| Title - Sujet Foyer and Classroom Renovation | |
| Solicitation No. - N° de l'invitation F1700-180006/B | Amendment No. - N° modif. 005 |

This Amendment #005 is raised to Issue Addendum #01.

| Project Title | PSEC - CLASSROOM ADDITION AND RENOVATION | | DATE: 03/10/2018 | Rev | ISSUED FOR | DATE |

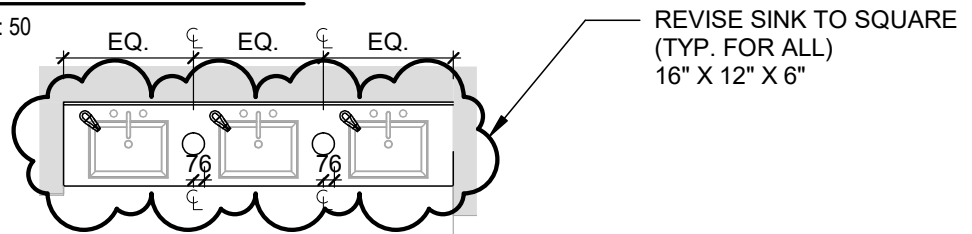
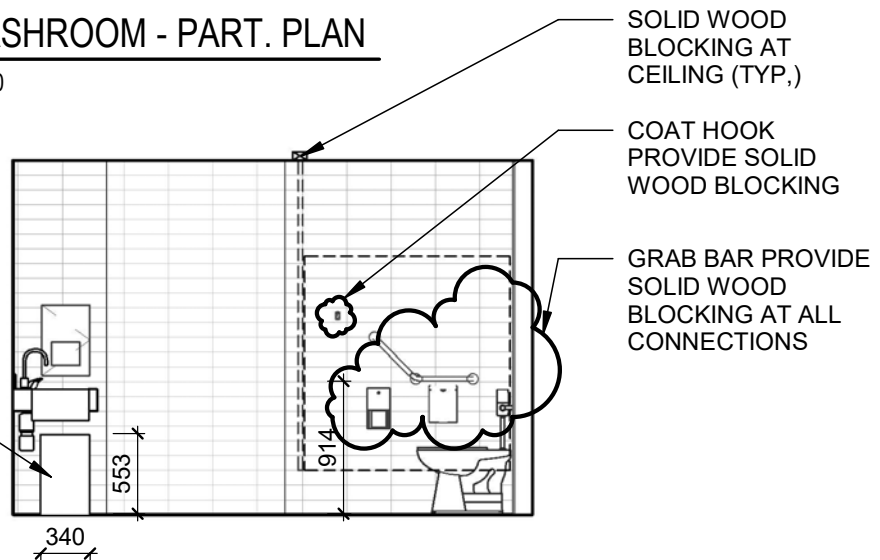
1. REFER TO ATTACHED FINISH MATERIAL AND COLOUR LIST – RENOVATION
2. REFER TO ATTACHED DRAWING ASK#1
3. REVISIONS IN SPECIFICATIONS:
 - a. SECTION 09 51 00
 - Revise part 2.2.8:
 - o Sizes: 600 mm x **600** mm x 19 mm (for metric grid).
 - b. SECTION 10 28 00
 - Delete part 2.2.3
 - Revise part 3.2.3:
 - o Semi-recessed towel dispenser: one in each washroom where indicated. Maximum height of dispenser and operable part from floor 1200 mm.
 - Delete part 3.2.9
4. CLARIFICATIONS TO QUESTIONS SUBMITTED

BOBRICK
B-2260
FLOOR-STANDING
WASTE
RECEPTACLE
WITH OPEN TOP
